DEVELOPMENT REVIEW COMMITTEE (DRC) COMMENT SHEET
CITY OF ROCKWALL ♦ PLANNING AND ZONING DEPARTMENT
PHONE (972) 771-7745 ♦ FAX (972)771-7748 ♦ PLANNING@ROCKWALL.COM

Project Number: SP2008-023
Project Name: Larsen Retail Development
Project Type: SITE PLAN
Project Subtype:

**LARSEN RETAIL DEVELOPMENT
3.339 AC. TRACT
LARSEN SCHOOL ADDITION
ROCKWALL, ROCKWALL COUNTY, TEXAS**

SITE PLAN -- PHOTOMETRIC ANALYSIS
 SCALE: 1" = 30'

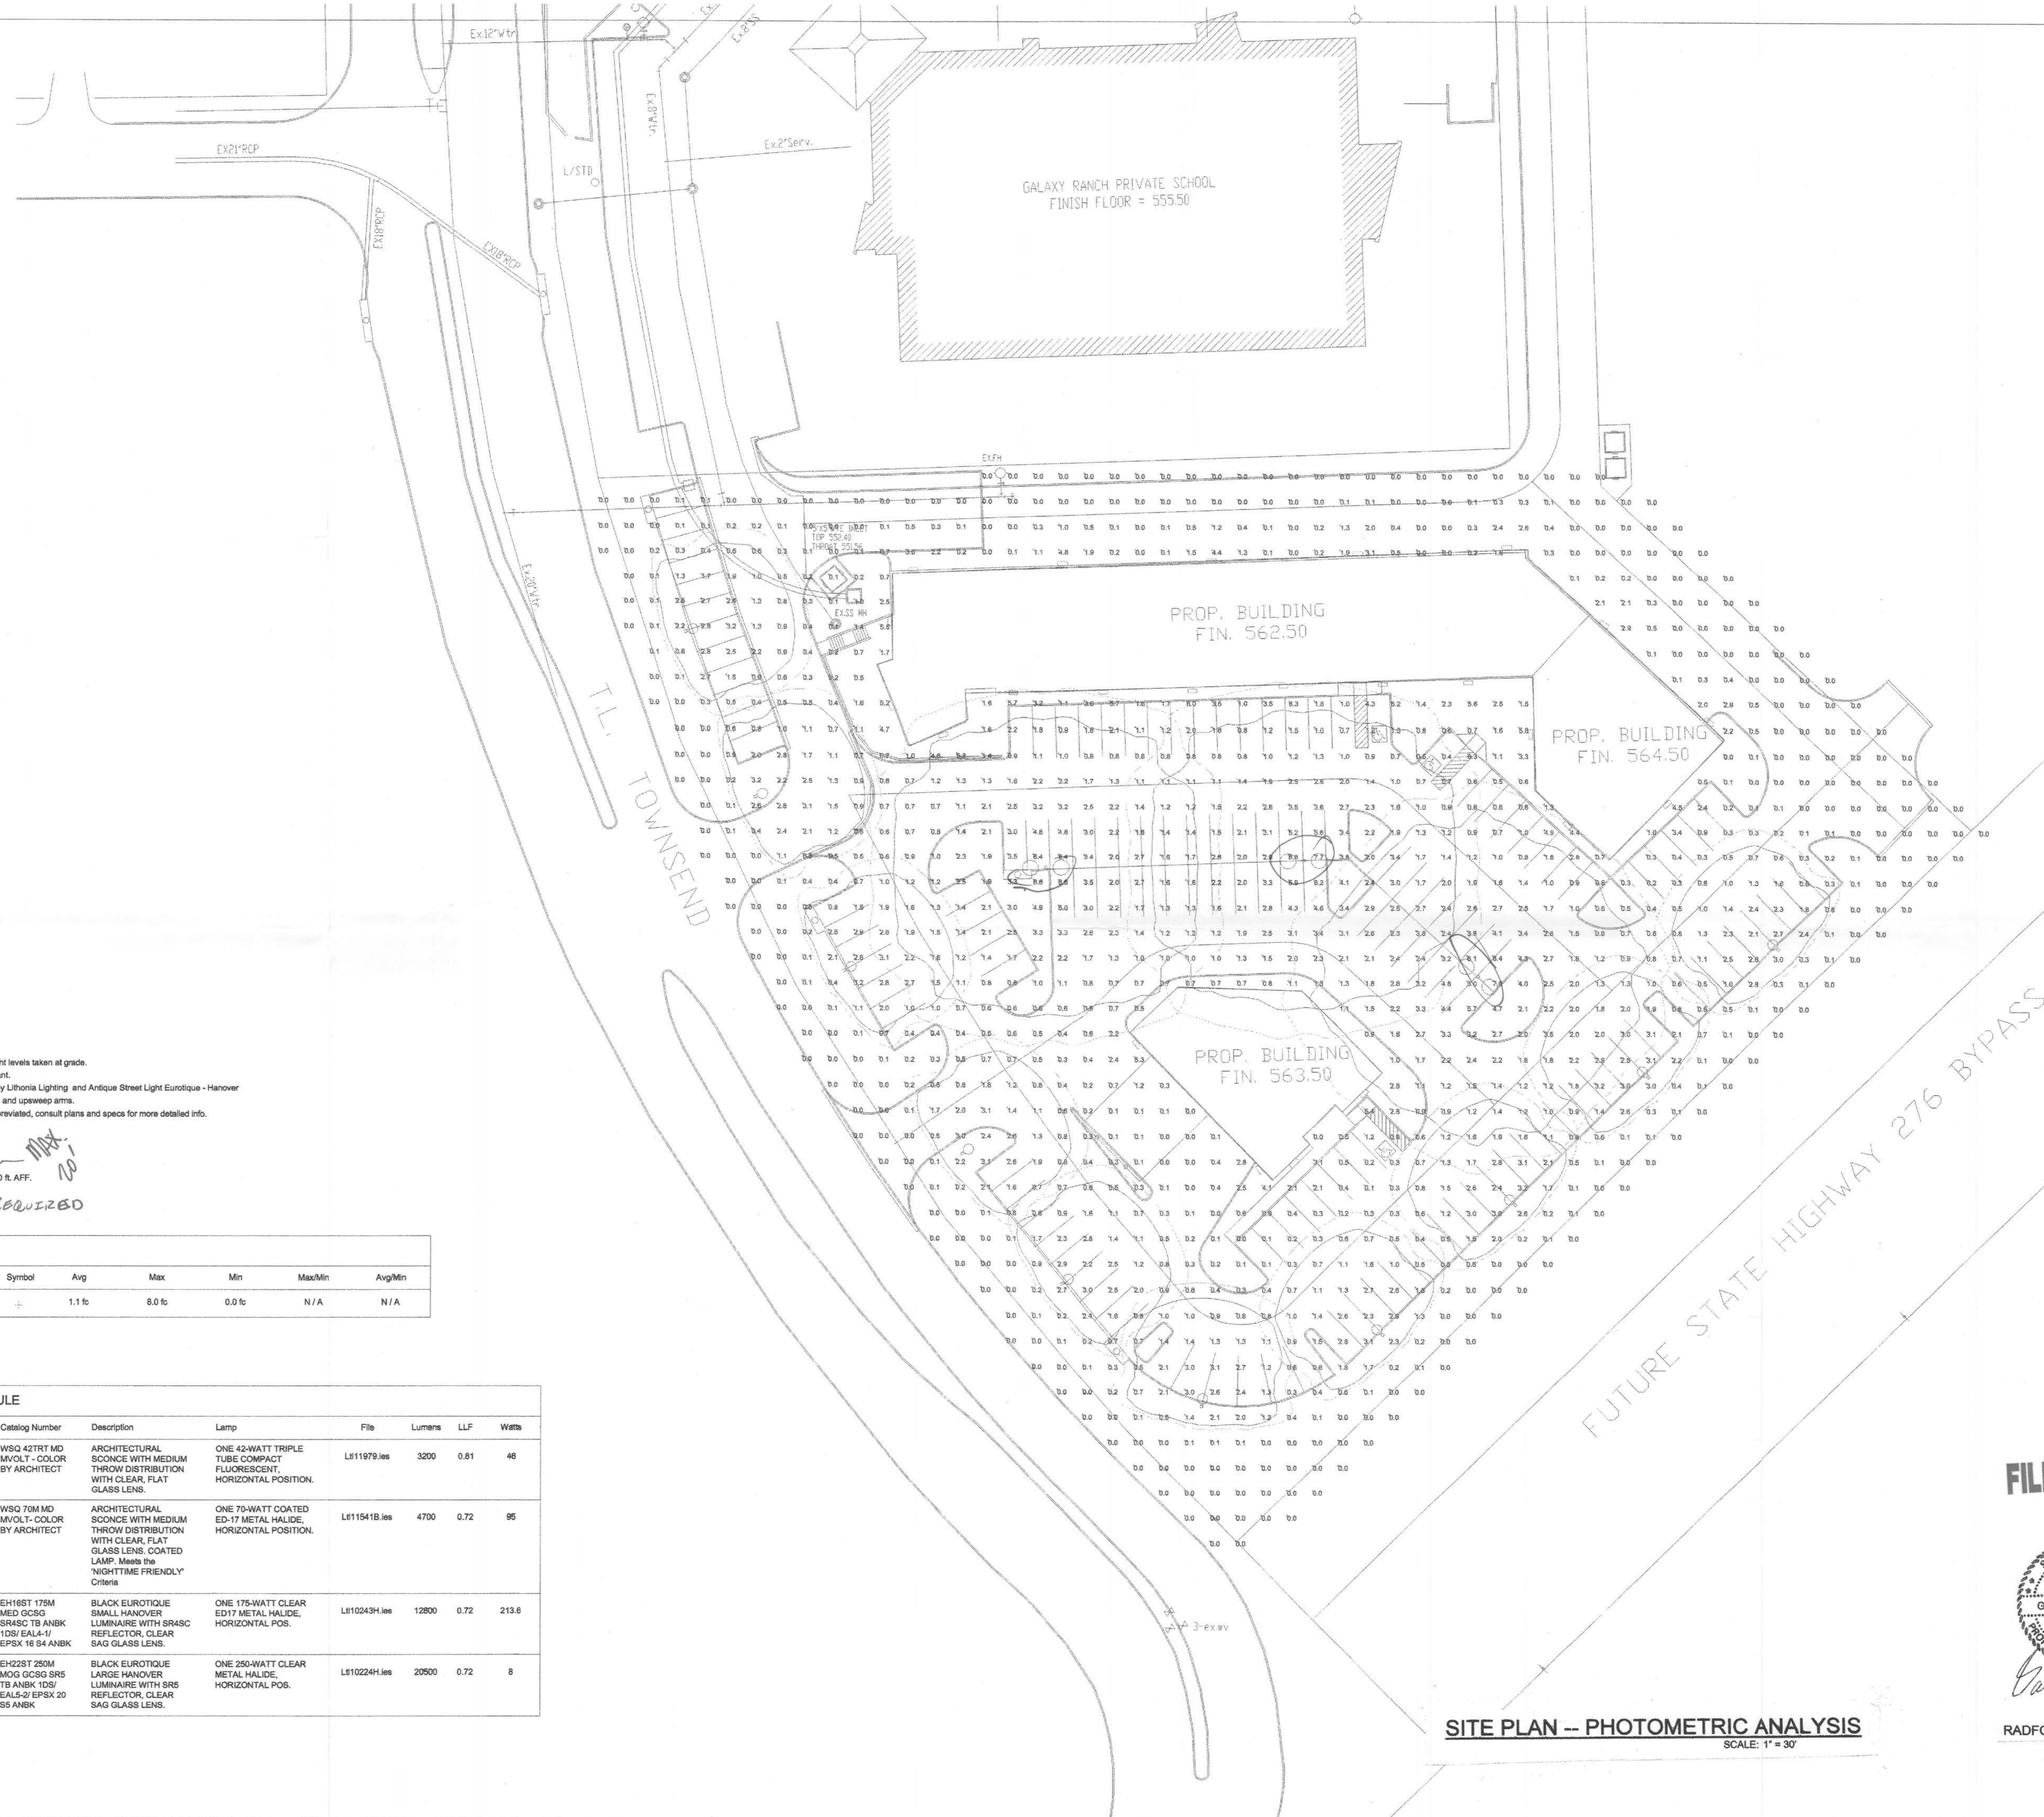
CUT-SHEETS REQUIRED
